FUEL LINE UPDATE SP4208-010, HOSE CLAMP 3225T5

FIA TYPE 1 PART

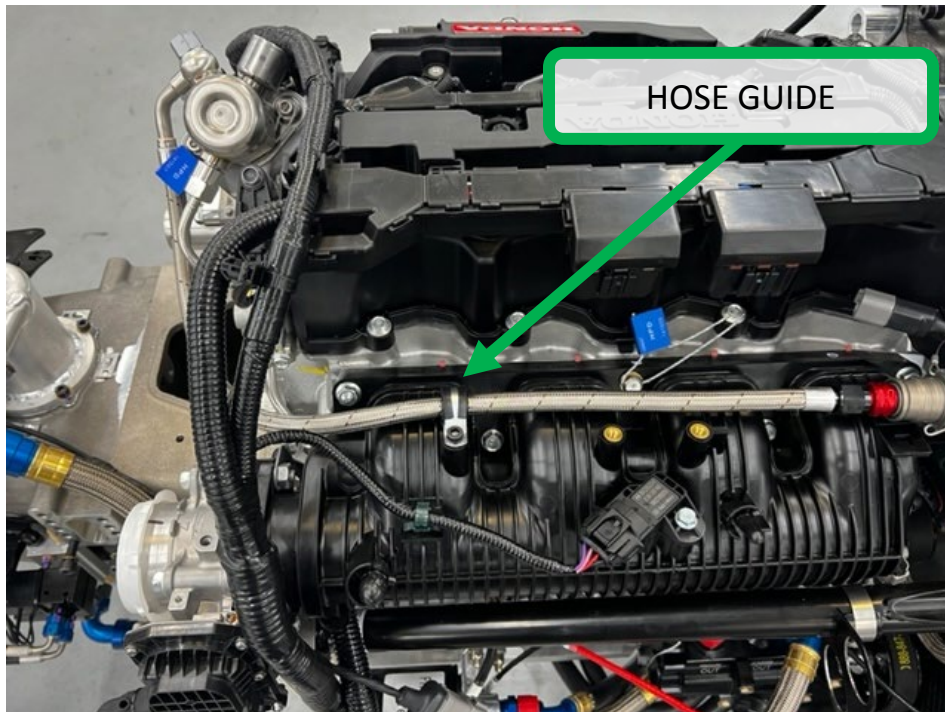
The low pressure side fuel line has been updated in order to increase longevity and combat any clearance issues with the Air-box. Additionally, a hose clamp is added to guide the hose. This is a mandatory update, Type 1 part, required starting at the 2022 Road America Event.

Each line comes with 2 new OE sealing washers (PN 90428-RPY-G01) to be replaced at the time of installation. It is required to use the Honda banjo "nut" that is on the High Pressure Pump.

The angle of the line should be such that it does not rub against another component, pay special attention to ensure the engine seal is not in contact with the line.

!CAUTION! - ONLY THE HOSE CLAMP SPECIFIED MAY BE USED. THE HOSE CLAMP IS USED AS A GUIDE SO MUST BE A 'LOOSE' FIT ON THE FUEL LINE, NOT CLAMPED TO THE LINE.

BANJO NUT TORQUE:
24 LB FT

IMPROPER INSTALLATION WITH SEAL
RUBBING ON THE LINE

HOSE GUIDE

Banjo Nut Torque: 24 Lb Ft
